## ***Interactive comment on “A global lake and reservoir volume analysis using a surface water dataset and satellite altimetry” by Tim Busker et al.***

**Tim Busker et al.**

**Fig. 1.** Area-level regressions for Lake Powell (a), Kariba (b), Mead (c) and Nasser (d), with  $R^2$  values of respectively 0.99, 0.96, 0.98 and 0.92.

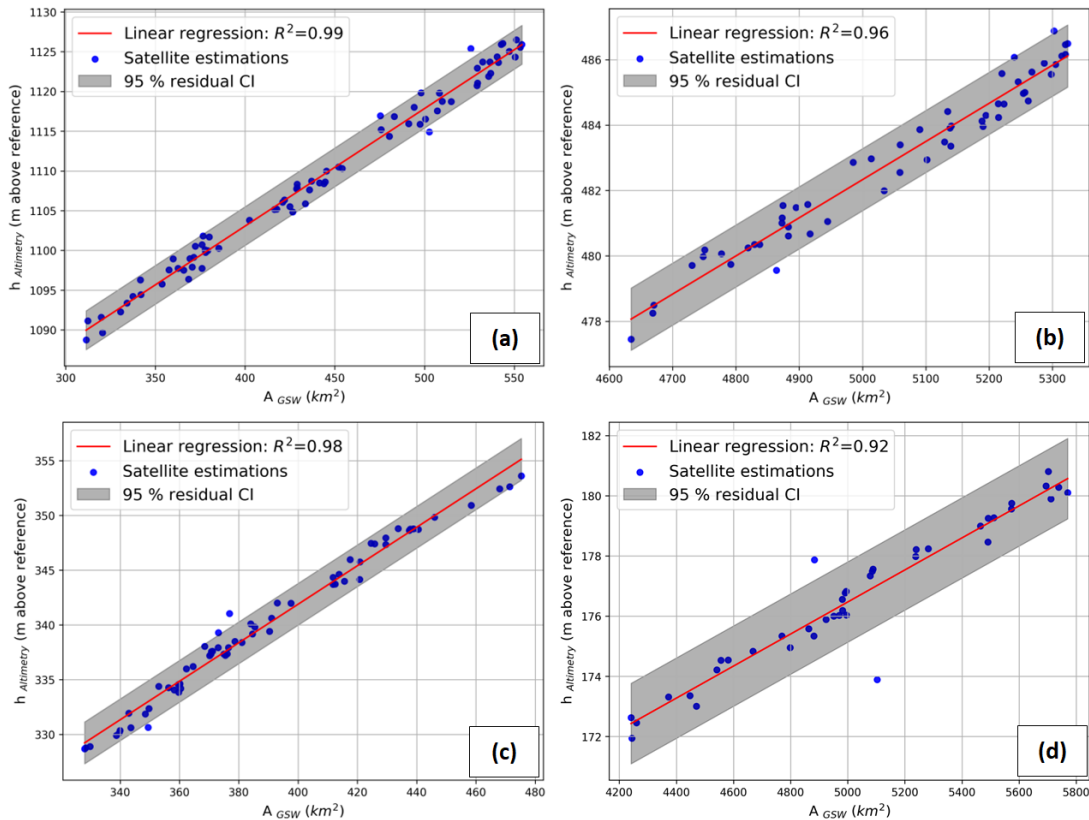
3) *Page 10, Figure 4: there are large departures in the plot for Lake Nasser – what could cause these? How significant are they?*

7) *Page 15, line 1: Yes, extrapolating beyond the limits of the data will result in higher errors. This is why the uncertainty in the regressed coefficients should be reported. Even then, the uncertainty estimated from the regressed quantities will be a lower bound on the uncertainty in the extrapolation as the estimate is based on the assumption that the fitted function still holds. Possible explanation for the over-estimation of the extrapolated storage for Lake Mead shown in Figure 8 (regressed coefficients are time dependent, or relationship is not as linear as was originally thought), or is the red line shown there within the uncertainty bounds for the original regression?*

These outliers may be caused by time lags between altimetry measurements and Landsat observations in the GSW dataset, as explained in the second paragraph of section 5.3. We cannot correct for this uncertainty, as the GSW dataset did not save the exact dates of the Landsat observations, but only provides the month of observation. Therefore, the time lag between the measurements can be up to one month. In this extreme case of the outliers for Lake Nasser, both water levels were measured in the beginning of the month (2th and 6th day) and were the only measurements available during that month. For the next month, we observed a considerable change in water level. The area and water level observations thus likely referred to different lake conditions, which could be a reasonable cause for the outliers seen in Figure 4d in the manuscript. How-

ever, these specific outliers do not have a large influence on the regression as they represent only 5 % of the residuals ( $n=41$ ). Considerable outliers caused by this effect are rare, as the water level change within a month has to be big, the number of altimetry measurements limited and the difference in timing of the A and h observations considerable. However, we expect this effect to be an important overall contributor to the residuals. To account for the area-level regression uncertainties, we extend the analysis by estimating residual-based confidence intervals (see comment 7).

**We will add the following sentences to the revised version of the paper (page 19, line 8):** 'The outliers in the regression of Lake Nasser (Figure 4d) are expected to be largely induced by this uncertainty. For both outliers, the altimeter measurements were taken in the beginning of the month (2th and 6th day), and the water level changed considerably towards the next month. The Landsat observation therefore likely measured different lake conditions than the satellite altimeter'.

**Proposed correction:** In the revised manuscript we will substitute the residual term  $\epsilon_i$  with the  $\frac{1+\alpha}{2}$  and  $\frac{1-\alpha}{2}$  quantiles of the Gaussian distribution of  $\epsilon$  to estimate a 95 % CI around the regression (see Figure 1).

**Fig. 2.** Lake volume variations for Lake Powell (a), Kariba (b), Mead (c) and Nasser (d) using Valtimetry (blue) and VGSW (red).

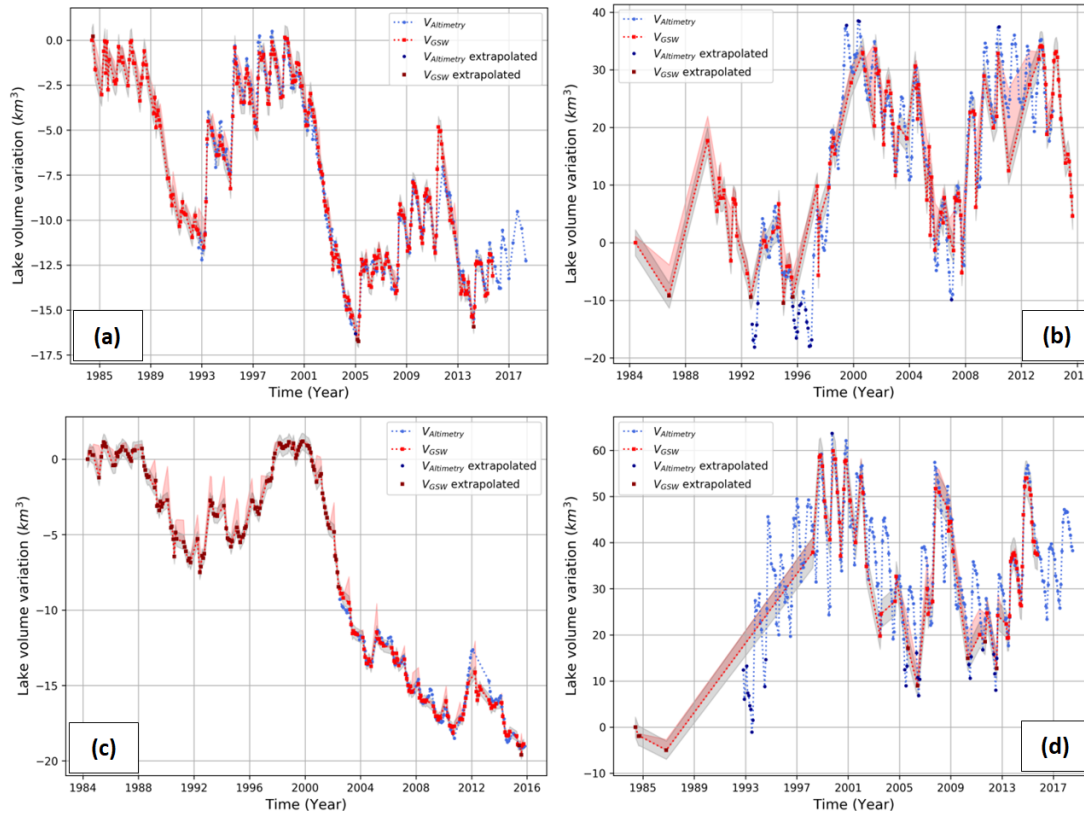
*4) Page 11, lines 14: It would be good to give some information on how the uncertainty was obtained, and how the no data pixels were treated in estimating the points shown in Figure 6. Are the red points likely to be lower bounds on the lake volume? From the Figure, these seems to be the case. If they are lower bounds, then the red shaded area seems to span between this low bound and an estimated upper bound. How are the individual pixels within the MWE converted to an area? Is this simply adding up the number of pixels with a detection of a water surface? Appears to be so based on what I can see, in which case this is a very simplified approach, and better estimates of the upper and lower bounds could be made by considering the part of wet pixels at other times (I note that some discussion on this appears in page 18, reinforcing my interpretation that the simplified approach has been used).*

However, we agree that we can explain this uncertainty in more detail. **Therefore we propose to substitute the sentence in line 13-16, page 11 with:** 'The red line displays the best estimate of the volume variation as calculated with observed water classifications in the GSW dataset (i.e. total area of surface water). The red shaded area displays the upper volume boundary on the  $V_{GSW}$  estimates, as derived from the GSW dataset pixels classified as no data within the MWE (max 5 %, see section 3.2). These no data pixels could theoretically be covered with water for that month, and this would increase the estimated area. In this case the volume variation estimation would be somewhere within the red shaded area. The upper limit of the red shaded area would thus be reached if all no data pixels within the MWE contain surface water during that particular month.'

We revised the old volume plots without a CI (Figure 6 in the manuscript) to volume plots with the 95 % residual-based CI (Figure 2) and the old validation plots (Figure 9 and 10 in the manuscript) to validation plots including the CI (Figure 3 and 4).
